## STAFF REPORT FOR THE PLANNING COMMISSION

**FILE NUMBER:** SUB-12-01

**REQUEST:** Proposed five lot subdivision at 23112 Bland Circle

Figure 9: Required Driveway Width

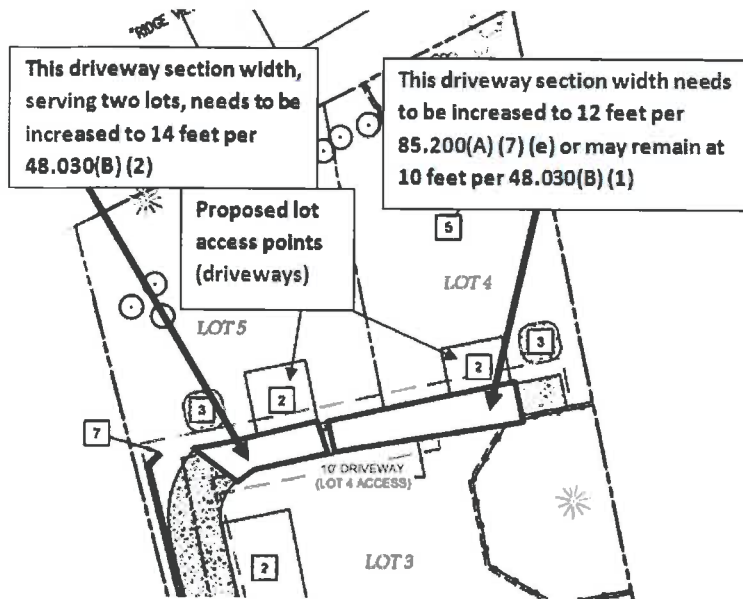
The width of the proposed driveway that would be shared by lots 4 and 5 needs to be increased to a minimum width of 14 feet to the east edge of the driveway that leads towards lot 5's garage to satisfy 48.030(B) (2) since two lots will be using that portion of driveway; and from that point eastwards towards and including proposed lot 4, the driveway width needs to be 12 feet wide per 85.200(A) (7) (e). (See Figure 9 and Staff Response 9).

2. Driveway width. The access driveway shared by lots 4 and 5 shall be increased to a minimum width of 14 feet to the east edge of the driveway that leads towards lot 5's garage. From that point eastwards towards and including lot 4, the driveway width shall be 12 feet (see Figure 9).

Figure 10: Fence along West Side of Driveway

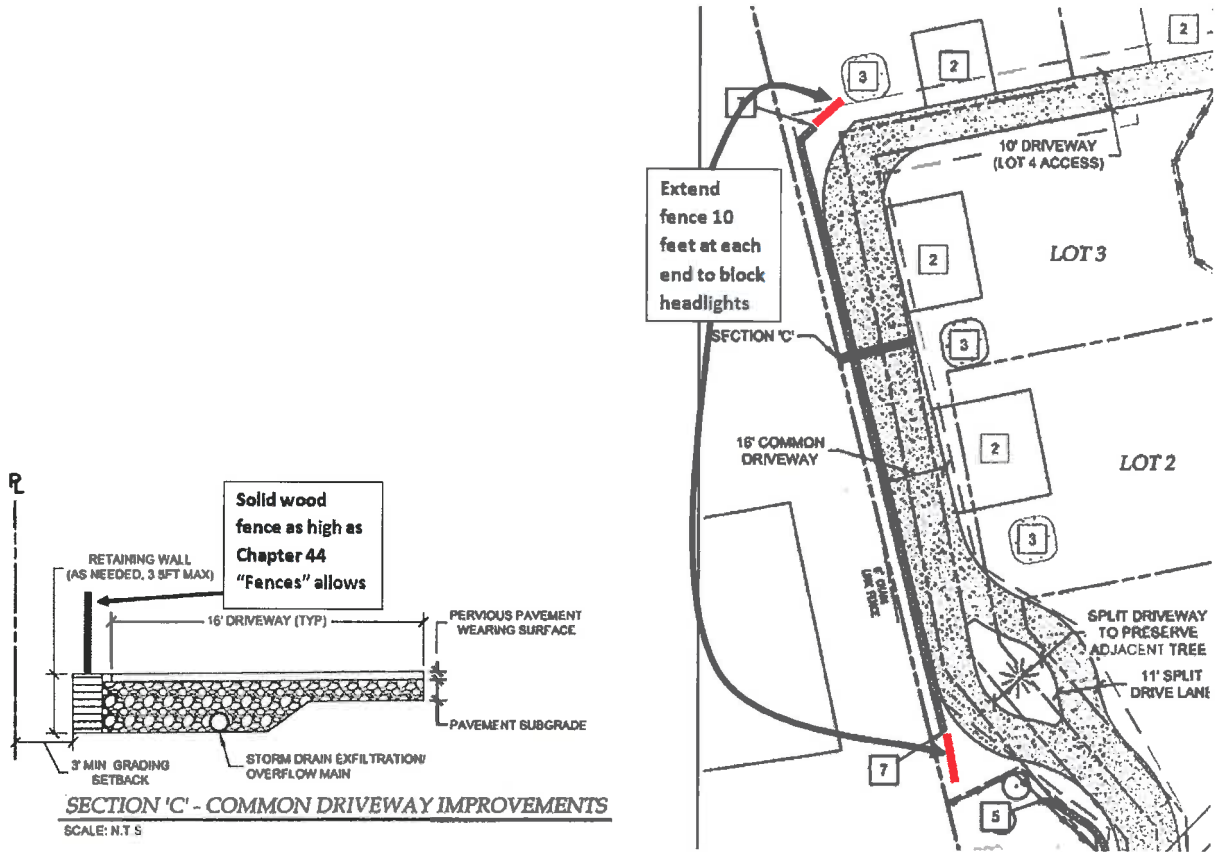
7. Fence. To shield the property to the west (23906 Bland Circle tax lot 501) from the headlights of vehicles using the driveway, the applicant shall install a solid wood fence, as high as Chapter 44 allows, on top of the retaining wall or graded slope along the west edge of the driveway (see illustration below). The fence shall either have the "good side" facing west with the construction side facing east or be identical on both sides. The fence shall extend ten feet beyond each end of the retaining wall shown on sheet C 2.1 (see Figure 10 below).

Figure 11: Proposed headlight glare and noise mitigation

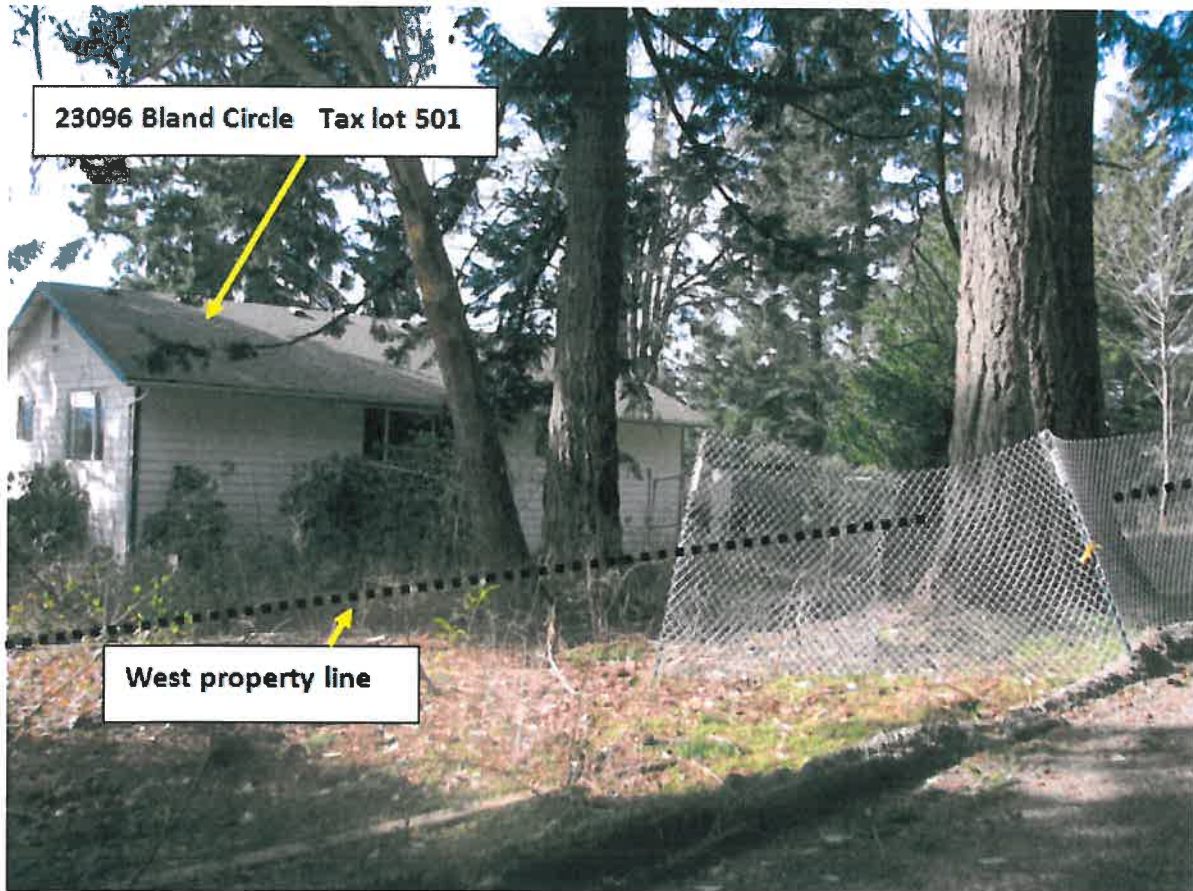
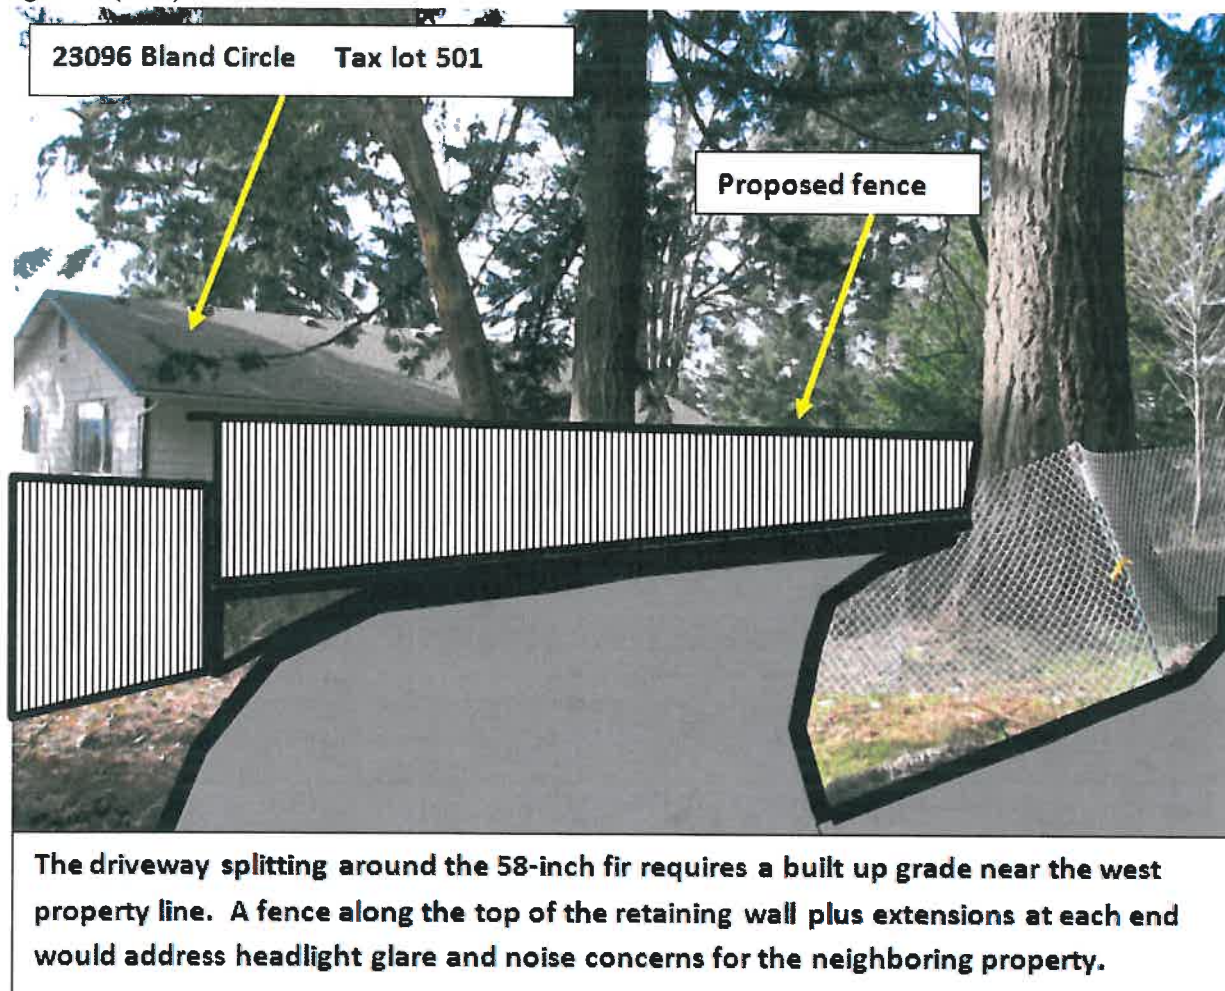
**Staff Response 1:** Staff finds that vehicular traffic on the private driveway (private driveways qualify as streets per CDC 02.030 "Definitions") could create glare and noise impacts for the residents of the house at 23096 Bland Circle (tax lot 501) as well as future development on that property. Whereas driveways between homes are not unusual, the specific site conditions at this subdivision are unique in that the applicant is building the grade up with retaining walls along the west property line so that the driveway will be eight feet above the grade of the house. So instead of the glare of headlights at normal grade, headlights will be significantly elevated and the glare will penetrate windows at the rear of the house only 25 feet away. Unbuffered vehicle noise is expected to affect the property as well.

Figure 12: Proposed street cross sections

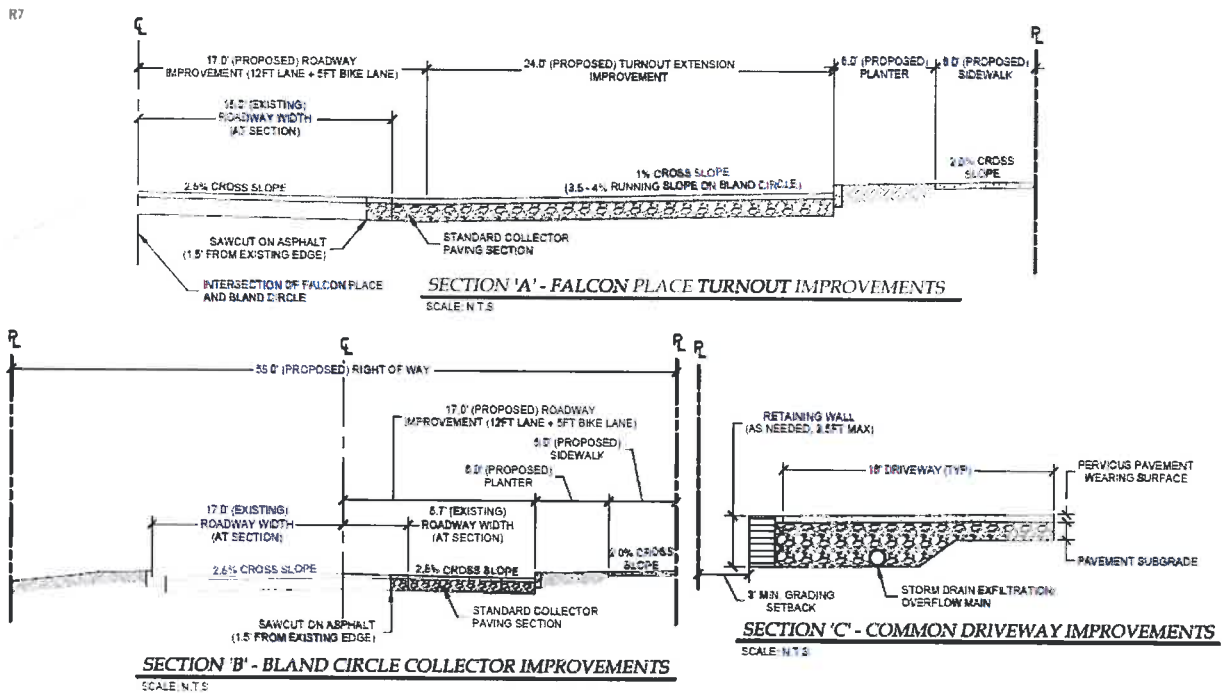
**Staff Response 2:** Staff finds that Bland Circle is a collector per the Transportation System Plan (TSP). The proposed 58 foot width meets the required width of the TSP for a collector. Cross sections of the proposed street and driveway improvements are shown below in Figure 12.

Staff also finds that the applicant has provided 62 feet of ROW and improvements as measured from the from Bland Circle centerline to the northern edge of the proposed “eyebrow” (Section “A” Falcon Place turn out improvement (see Figure 12)). This dimension will accommodate a 17-foot wide roadway and a 33-foot wide “eyebrow” plus a six-foot wide planter strip and six-foot wide sidewalk. For the non-eyebrow section the ROW will measure 29 feet from the centerline. Within that ROW, the applicant provides a 12-foot wide travel lane, a 5-foot wide bike lane and 6-foot wide planter strips and 6-foot wide sidewalks. Therefore staff determines that all of the improvements in the application meet or exceed the TSP standards.

Figure 16: Required driveway widths

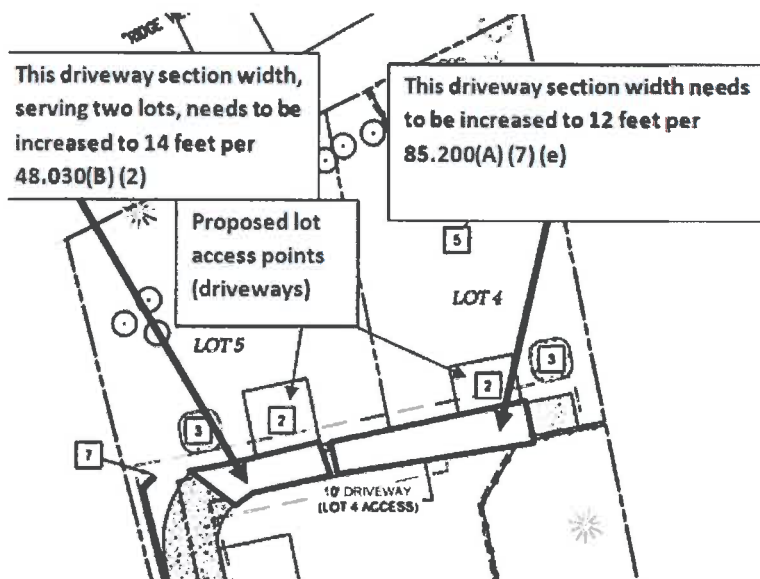
Staff also notes that the access driveway to lot 4 and 5, shown on sheet C2.1, (see Figure 16 below) measures 10 feet in width. This driveway dimension needs to be increased, per COA 2, to a minimum of 14 feet adjacent to lot 5 to satisfy 48.030(B) (2) since two lots will be using that portion of driveway while the driveway extending to lot 4 needs to be 12 feet wide per 85.200(A)(7)(e).

Figure 19: Grading plan for lot 1. The access driveway, the "eyebrow" and tree conservation easements dictate the grading plan.

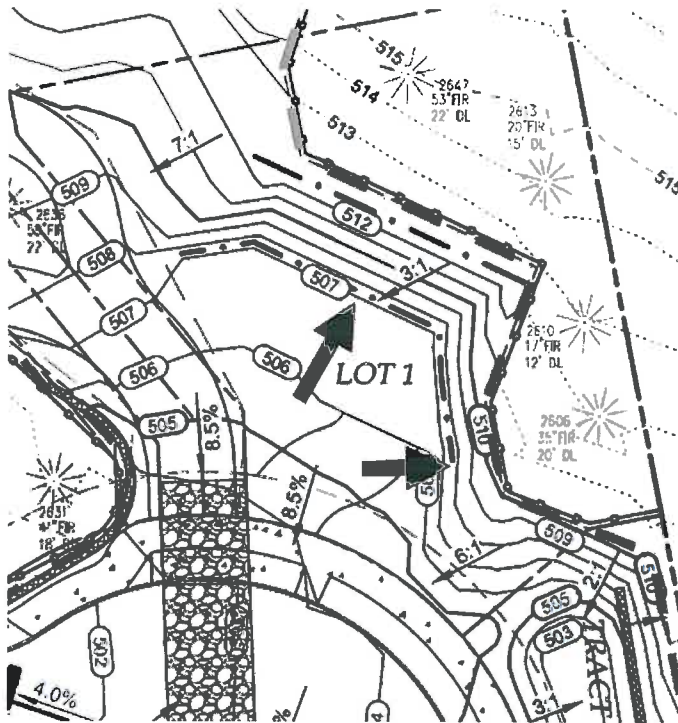
Meanwhile, proposed lot 1 is wedged between the driveway to the west, the “eyebrow” to the south and the tree conservation easements to the east. The “eyebrow” pushes the curb 30 feet back from a traditional street design on Bland Circle. This means that there is a much steeper 14.5 percent slope from the curb to the 512 foot contour than if the traditional street section had been built. Staff finds that grading on proposed lot 1 is inevitable (see Figure 20 below).

The applicant states in a February 1, 2013 letter that the grading is needed to accommodate a reasonable building area of 1,665 square feet. If there was no grading allowed on lot 1 and instead the transition in grades was accomplished by the construction of a retaining wall at the proposed 507 foot contour, the applicant would be limited to a house footprint of 610 feet and a house depth of about 20 feet. Staff acknowledges those constraints as unworkable. Staff is agreeable to a condition, proposed by the applicant, which would allow the grading plan (sheet C2.3) so long as a licensed arborist is in attendance during the grading and any site development. The City Arborist agrees with this proposed plan and condition.
